RE PLANNING APPLICATION F/23/96589 – MOORLANDS FARM, BOTLEY ROAD, WEST END, SOUTHAMPTON

Thank you for your Council's letter of 10 April 2024 consulting on the revised plans added to the above Planning Application. On behalf of the Ramblers' Association, we hereby lodge an objection to the above application on the grounds that inadequate consideration has been given to the relationship of the proposed access road to Footpath No 10 West End.

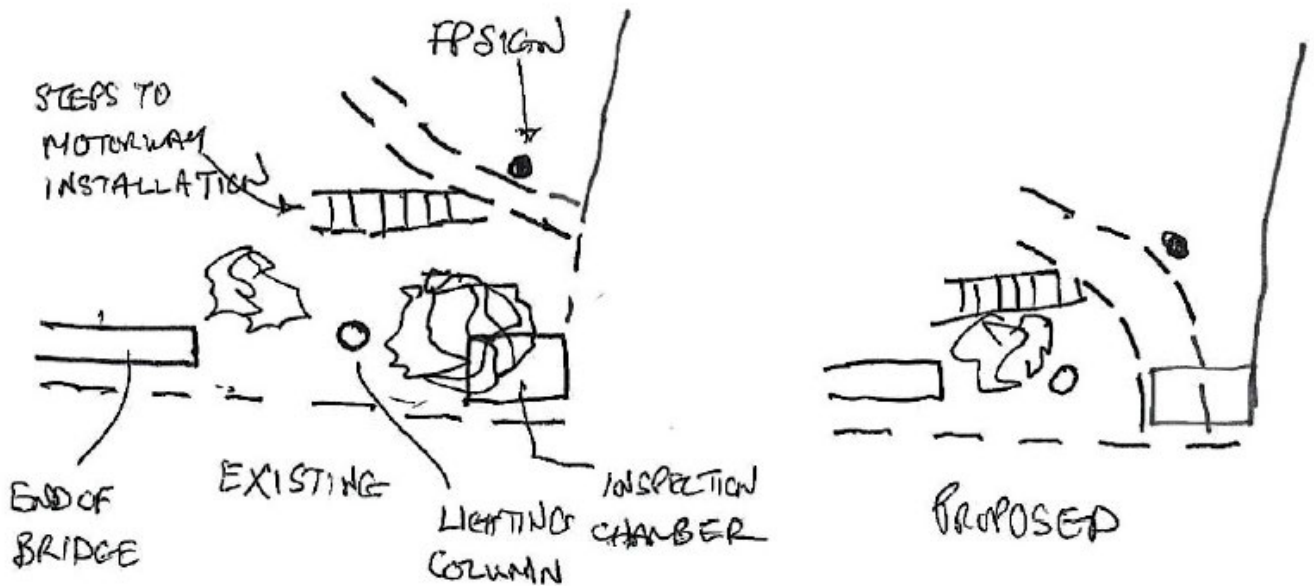
The footpath was created as a result of a diversion when the motorway was constructed and we have added an extract from the plan in the Diversion Order of 18 November 1981. At that time the path would have been part of the land acquired for the construction of the motorway and the diversion of the path. The land over which the footpath was created passed from the Department of Transport to Hampshire County Council as a result of a Side Roads Order.

Above proposed footpath from across the Botley Road – below close up.

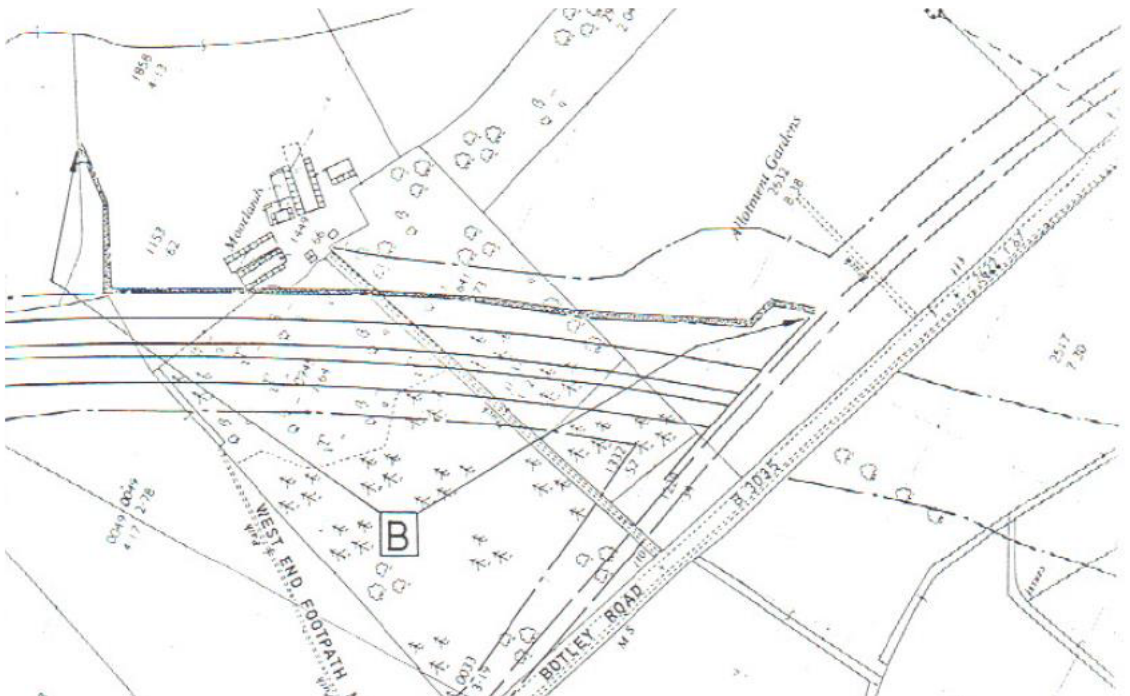
The footpath physically is not where it is shown on the site plan and it fails to show it continuing to the back of footway on Botley Road as per the Diversion plan. With the clearance of the bushes to the east of the lighting column it would be possible to create a footpath to Botley Road as shown on the sketch below. This is essential on safety grounds to avoid conflict with industrial traffic coming into the entrance. The inspection chamber should be shown as within the footpath and the footpath route protected and defined by road kerbs.
